## ADDENDUM No. 2

Date: August 13, 2025

Project: Roseburg Regional Airport  
Airport Fencing & Security Upgrades

1 TEMPORARY SECURITY FENCE  
NO SCALE

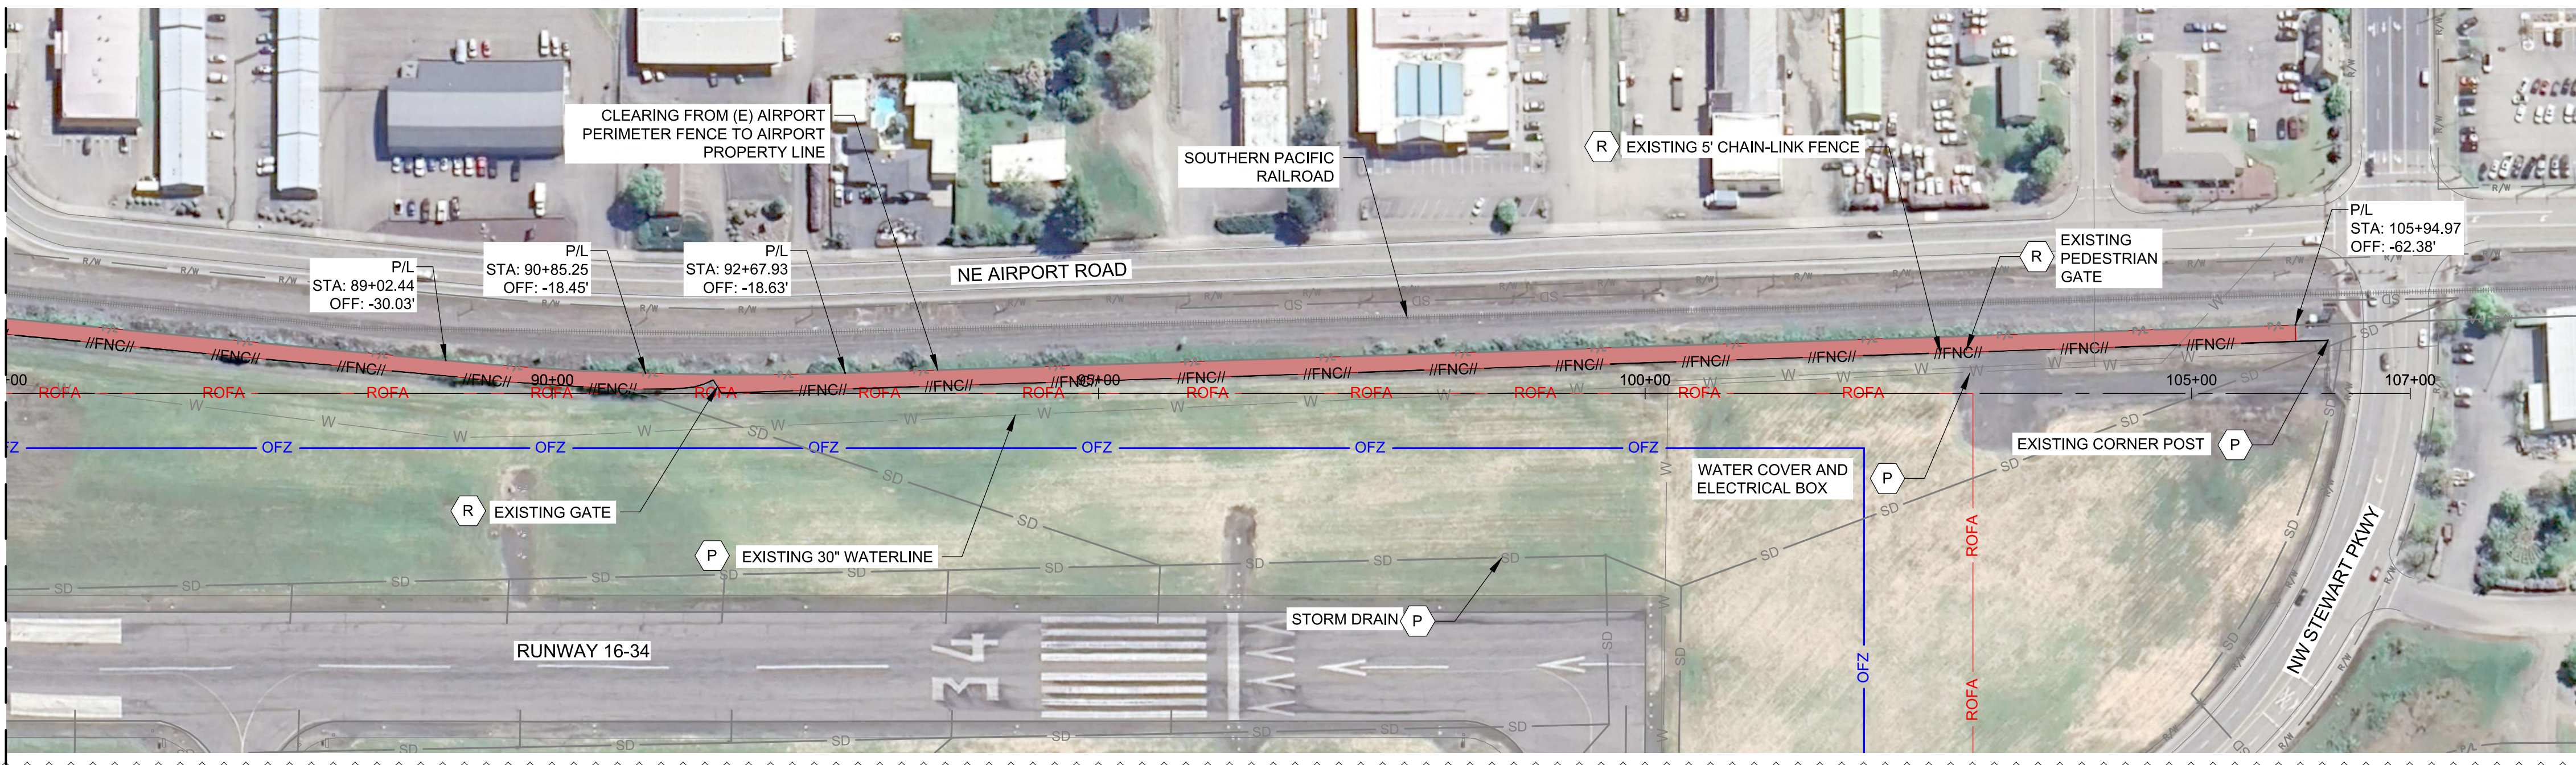
- Added detail 1 for Temporary Security Fencing.
- Revised Substantial Completion Date.

**Answer:** There is approximately 15' between existing fence and new fence alignment. The 300' of fence opening may be exceeded during construction, as long as at the end of each day's work, the airport is fenced off via either relocating the existing fence, repairing the existing fence, or construction of a temporary fence per detail 1/G-081.

C-051

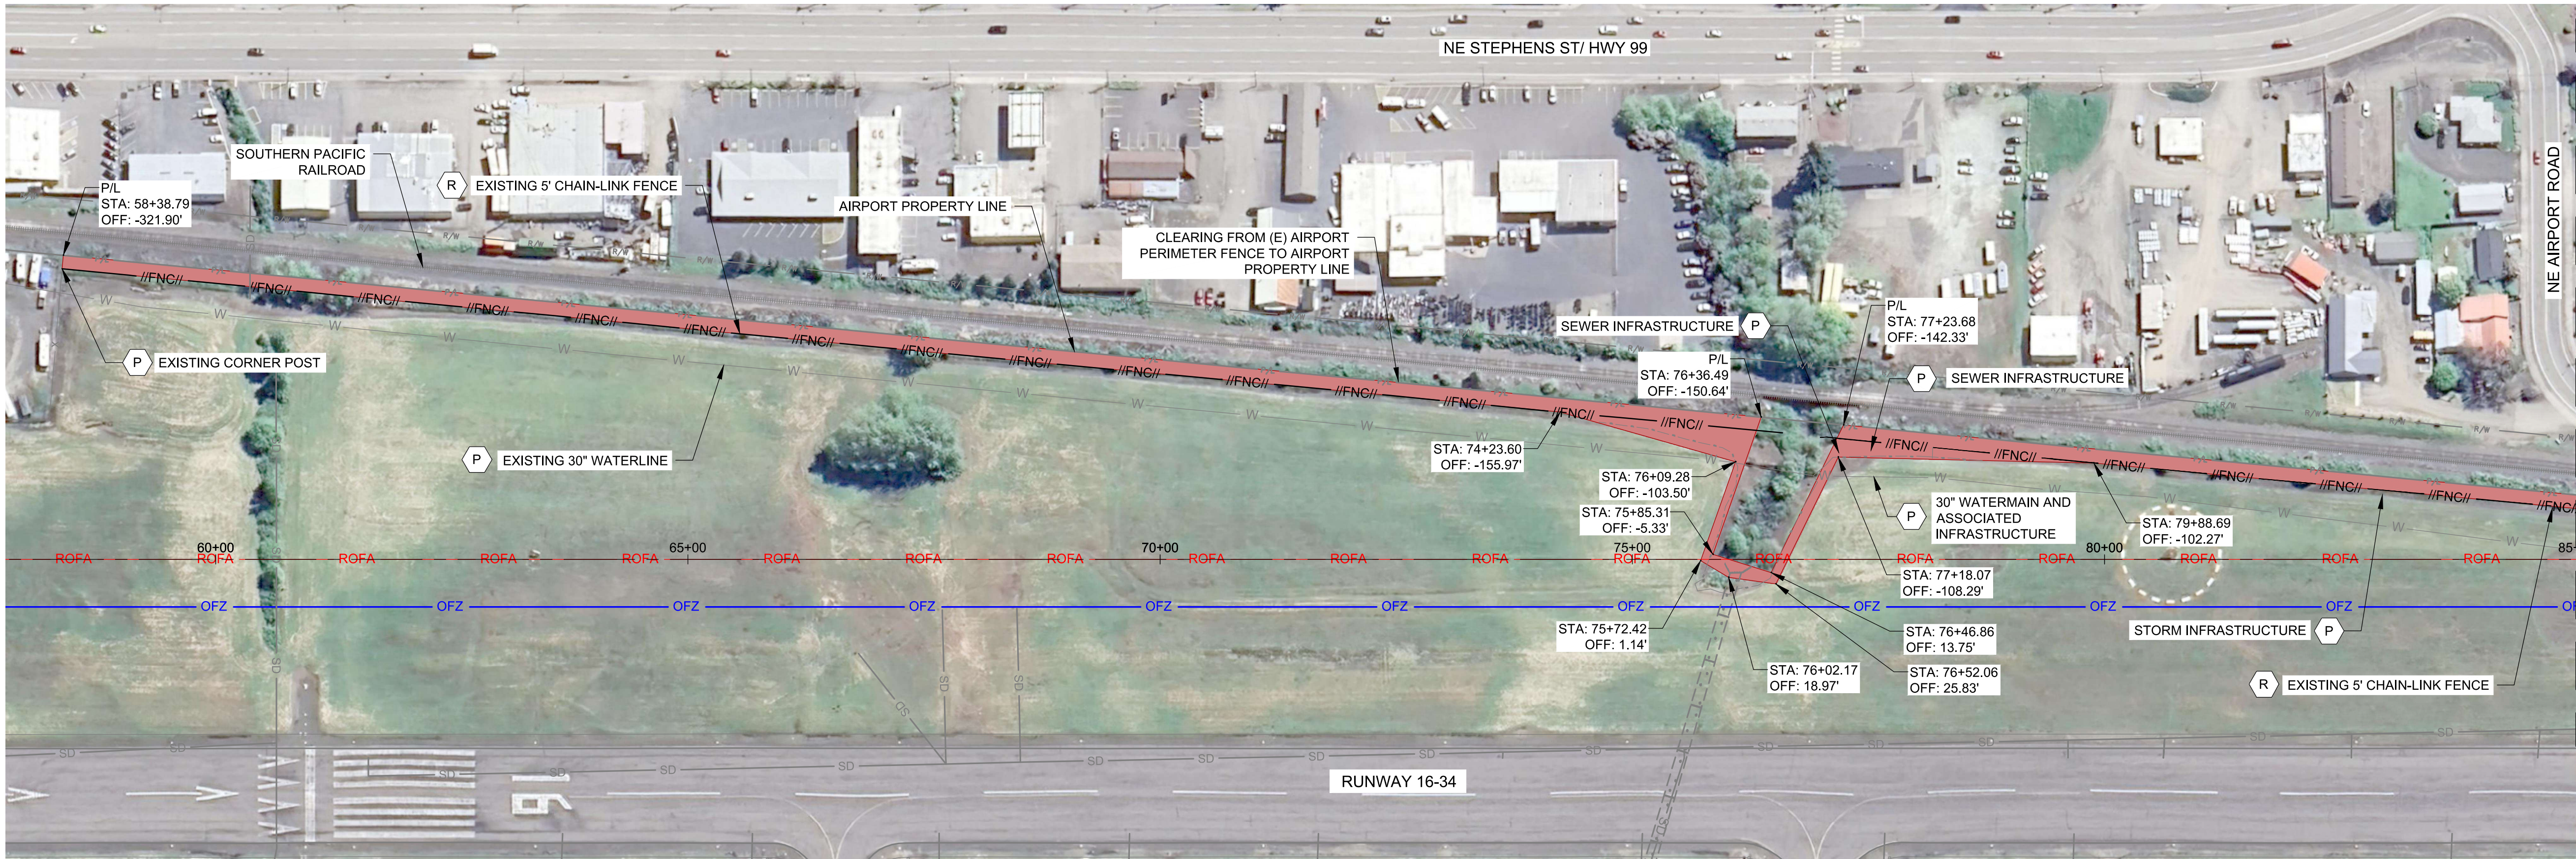
- Revised to show additional utility info.
- Revised note 3 to say "NTP"
- Added Note 5 to describe Temporary Security Fence.

**Answer:** Work Area 1: In lieu of keeping existing fence in place per note 5 on sheet C-051, the Contractor may at their own discretion relocate the existing fence location, or construct a temporary fence West of the existing fence line. Any relocated or temporary fence must be outside the ROFA. No separate payment will be made for the temporary or relocated fence.  
Work Area 2: Temporary fence required during Work Area 2 to maintain site security. See revised sheets as part of this addendum.

- EXISTING CHAIN-LINK FENCE AND GATE SHALL BE REMOVED IN ACCORDANCE WITH ITEM P-101.
- TO MAINTAIN SECURITY IN WORK AREA 1, THE EXISTING CHAIN-LINK FENCE SHALL REMAIN IN PLACE UNTIL THE NEW FENCE IS CONSTRUCTED. THE CONTRACTOR HAS THE OPTION TO RELOCATE THE EXISTING FENCE, OR CONSTRUCT A TEMPORARY SECURITY FENCE WEST PER DETAIL 1/G-081. ANY RELOCATED OR TEMPORARY SECURITY FENCE MUST BE PLACED OUTSIDE THE ROFA.

C-601

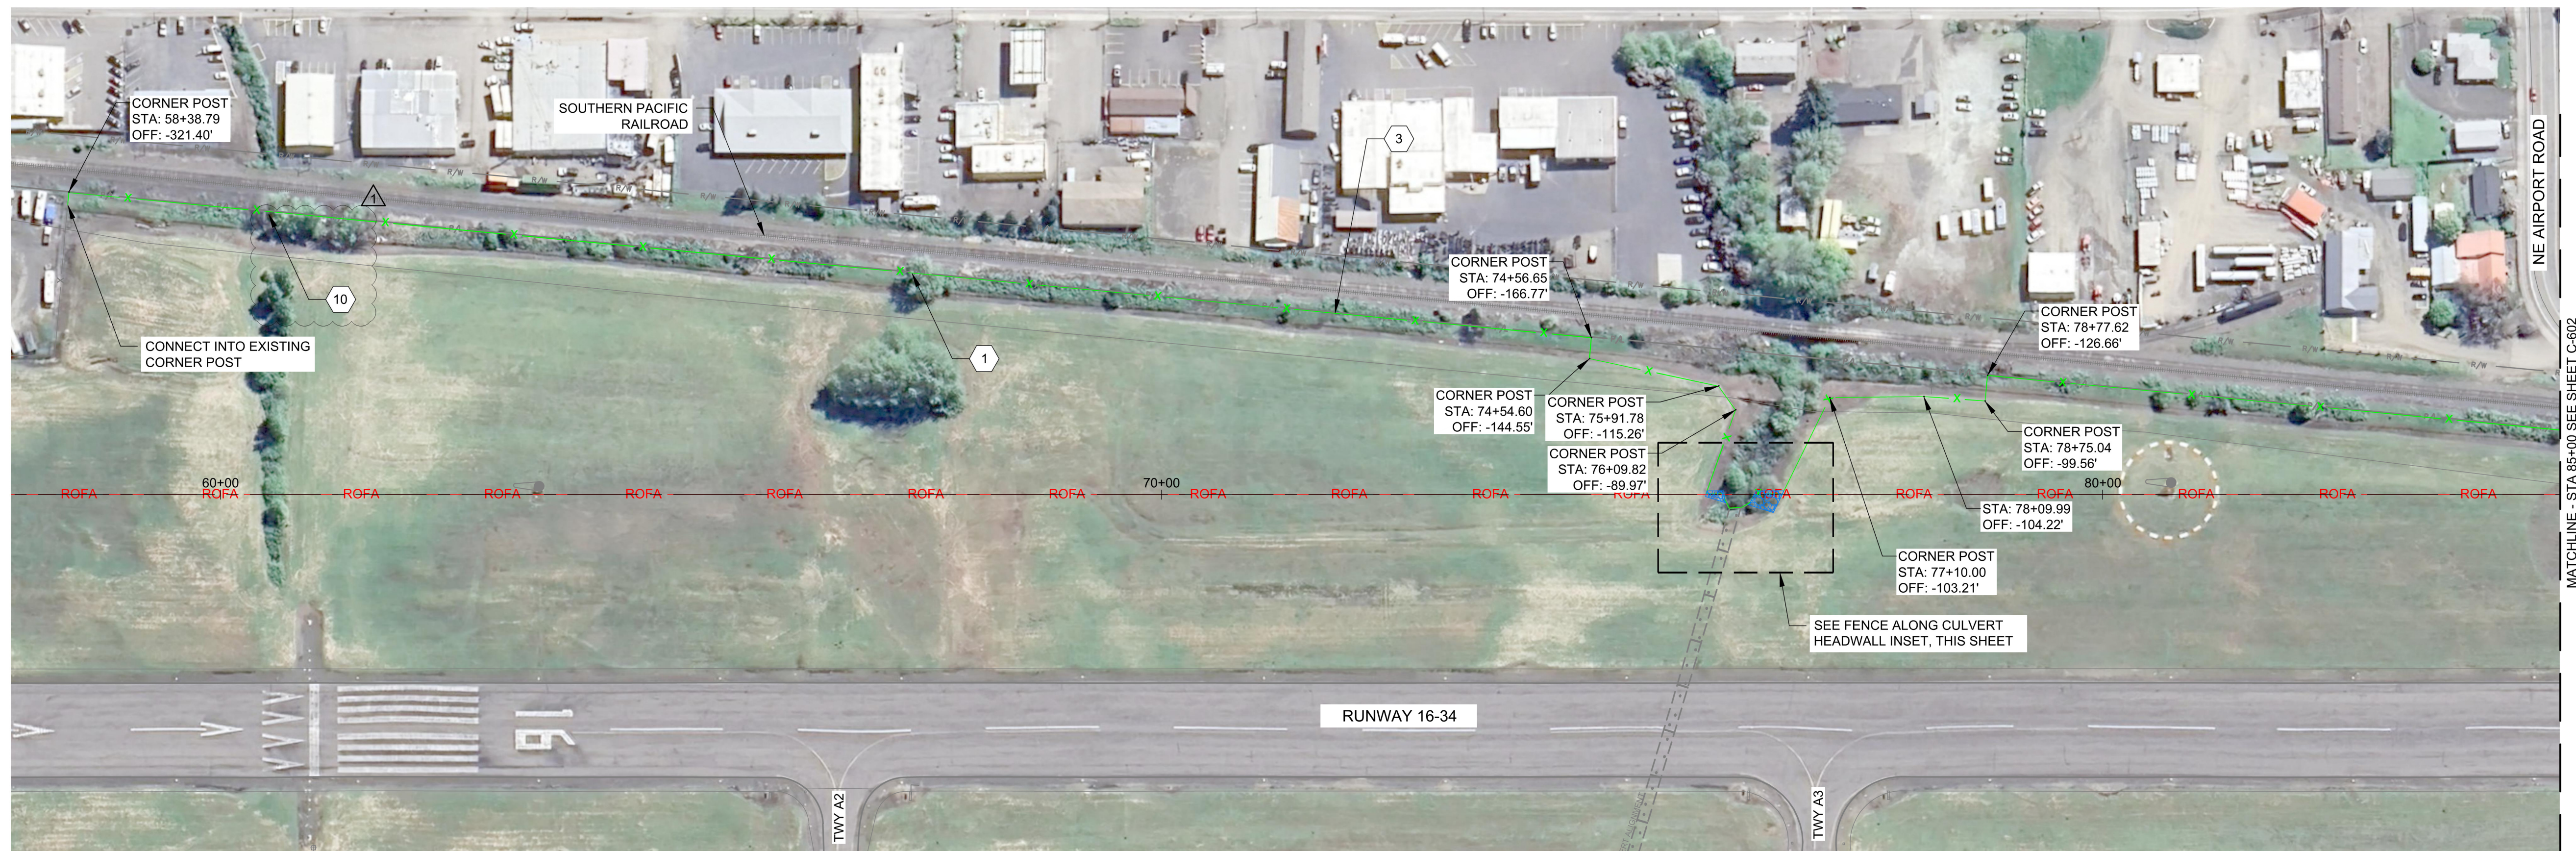
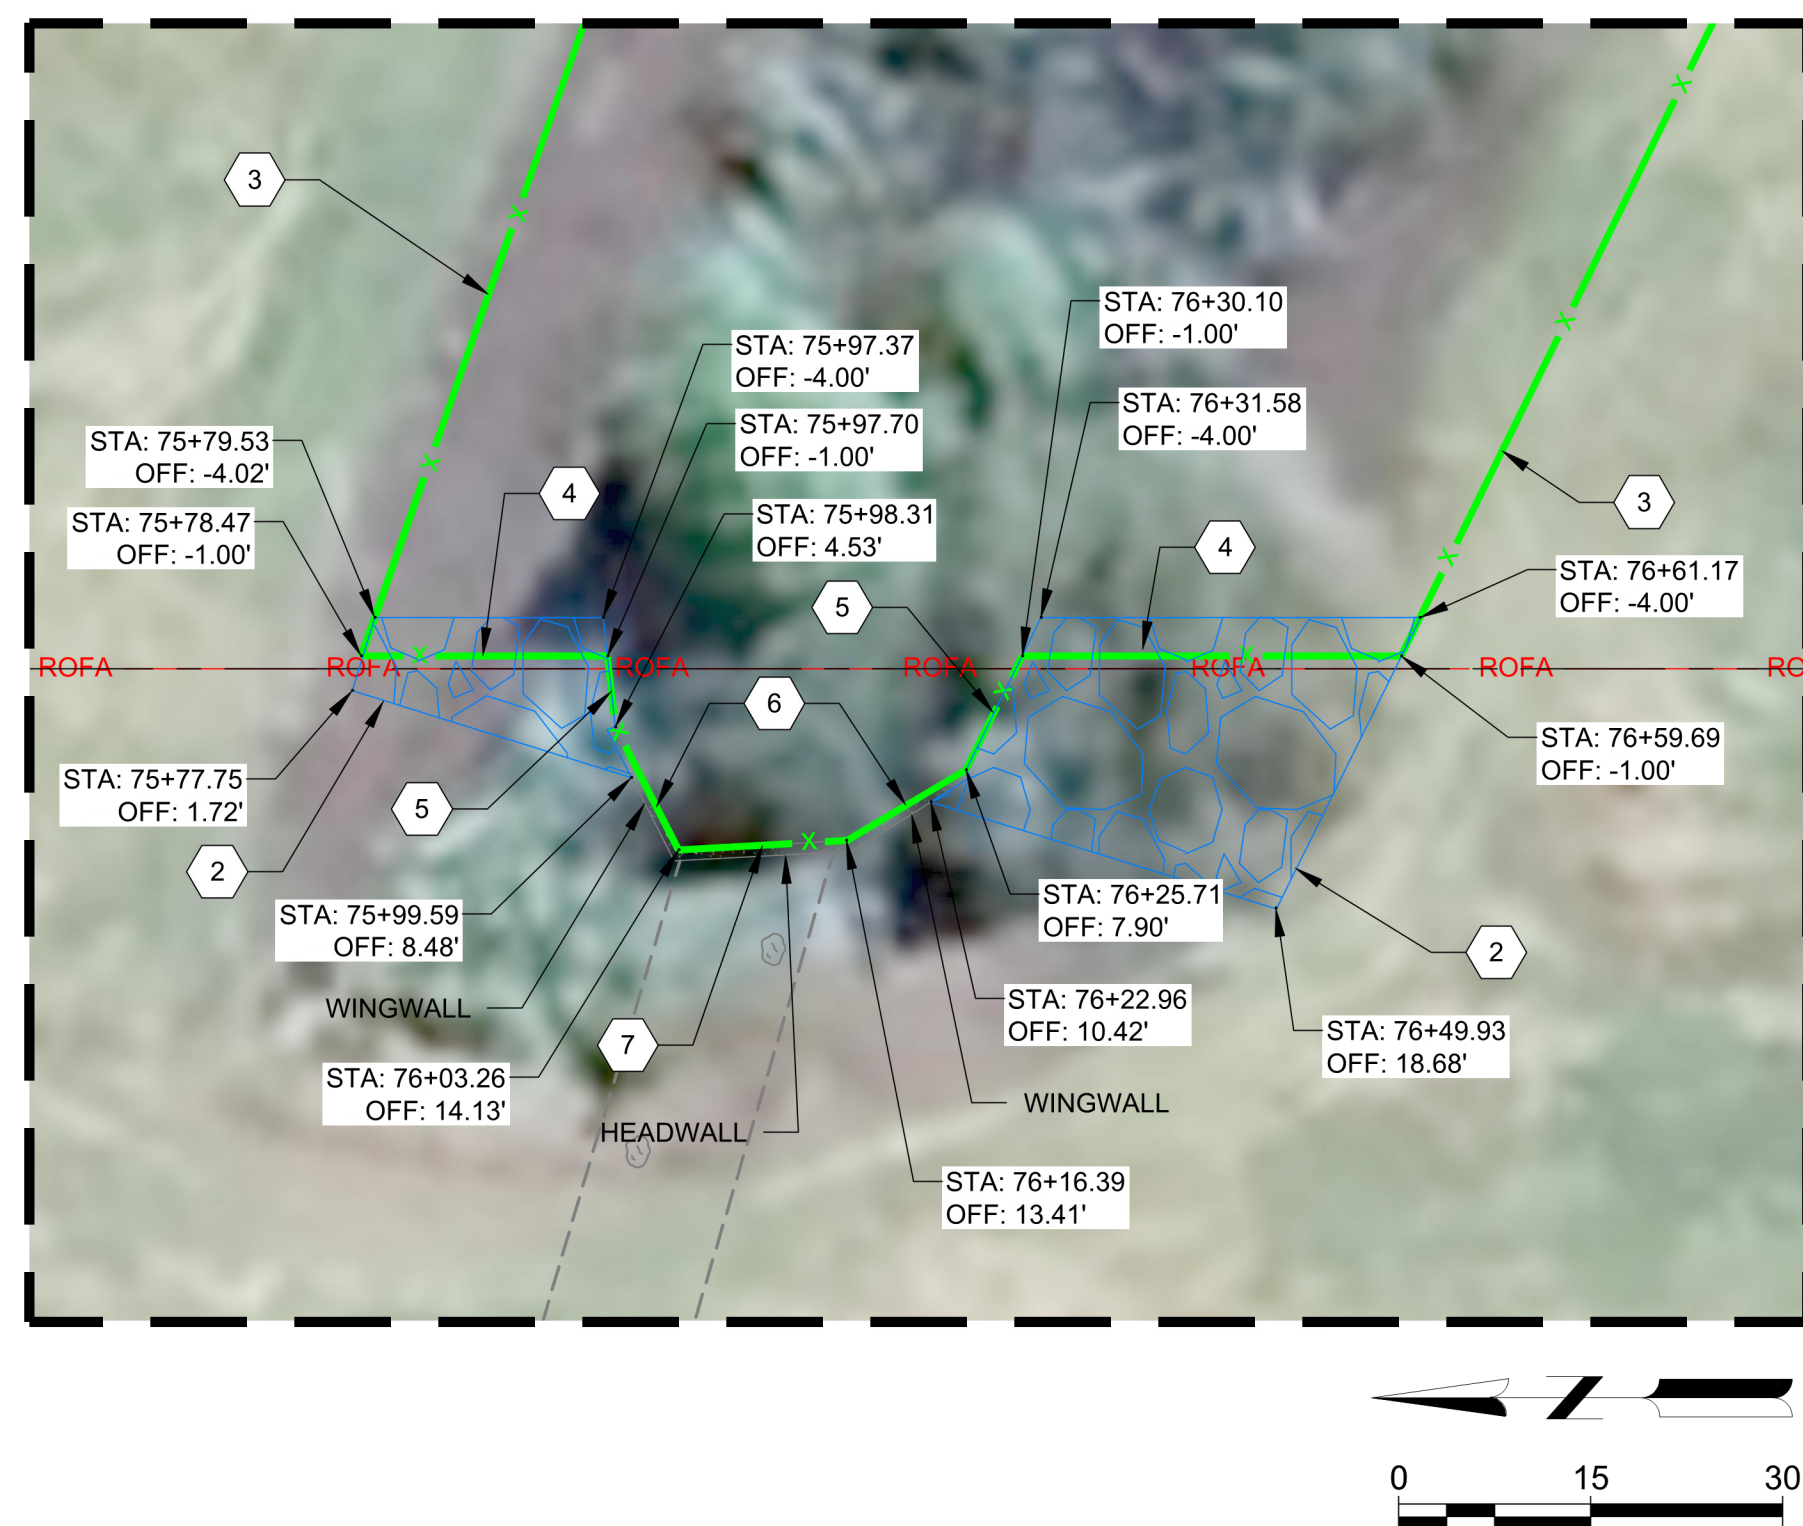
- Added Keynote 10 regarding fence alignment near ditch on North side of Work Area 1.

- 10 FENCING TO BE ROUTED AROUND DITCH ON THE UPSLOPE SIDE AND WITHIN THE PROPERTY LINE

C-603

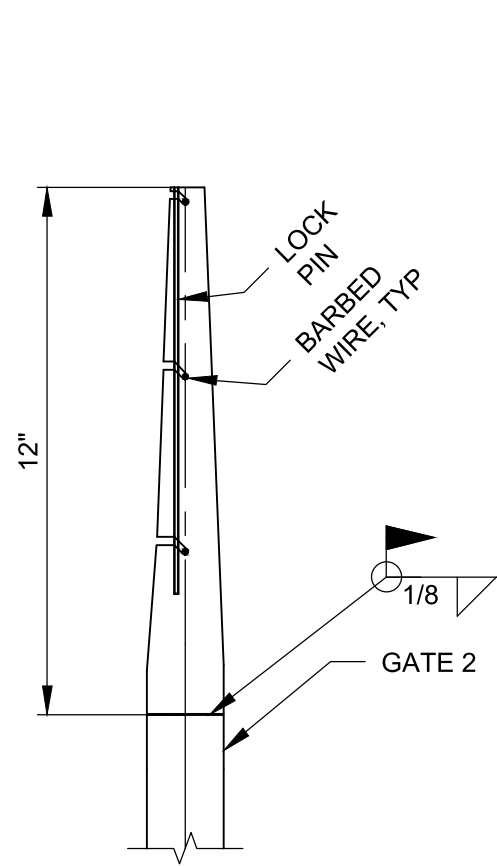
- Revised keynote reference for pedestrian gate.

16. **Question:** Sheet C-603. Shows an aerial view of the part of the site. It identifies a location for installation of pedestrian gate 2. Keynotes: 2. NOT USED  
These are in conflict. Please clarify.

**Answer:** Keynote 9 refers to pedestrian gate 2. See replacement sheet C-603.

**EXTENSION ARM DETAIL**

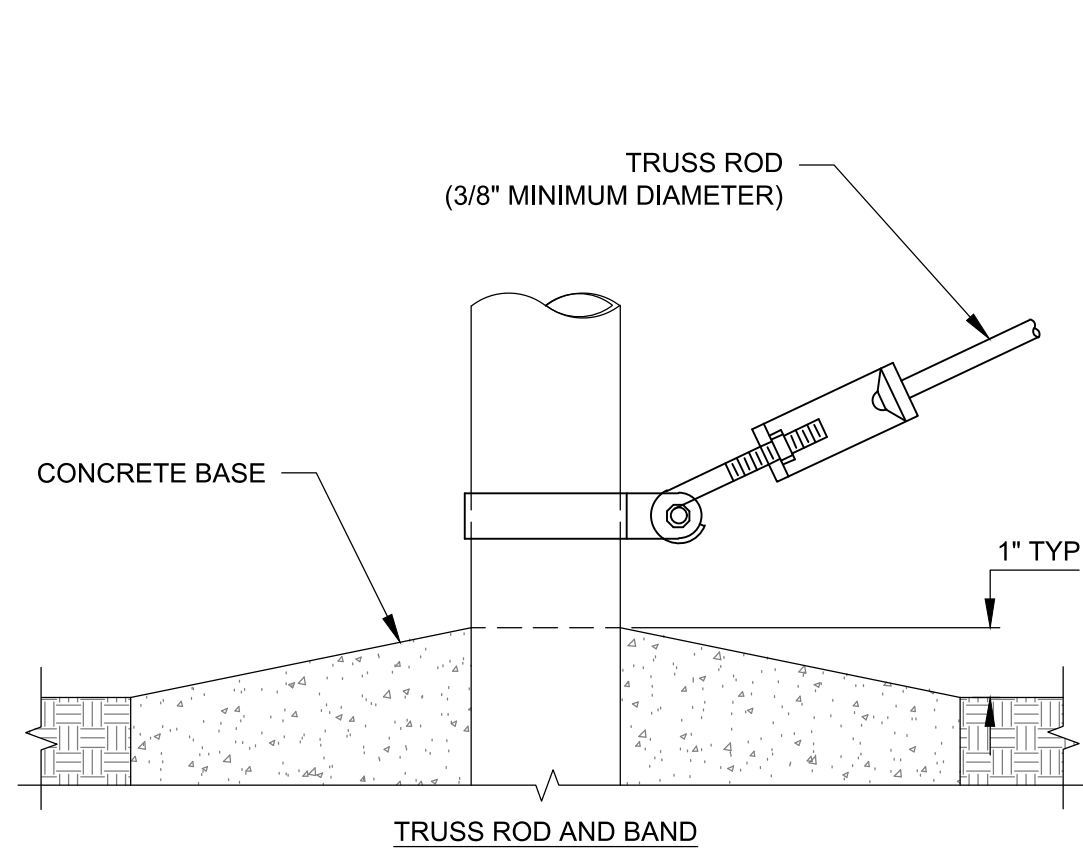
- Revised horizontal dimension on detail 3, extension arm detail.

11. **Question:** Sheet C-632. Detail 3. Extension Arm Detail.

The detail shown displays a horizontal snap measurement of 1'-6". This would put the arm six inches over the property line if the fence is to be constructed one foot back from the property line. The length of the Arm as detailed creates a conflict with the one-foot set back from the property line for construction of the fence.

**Answer:** Horizontal measurement of the extension arm should be 12". See replacement sheet C-632.
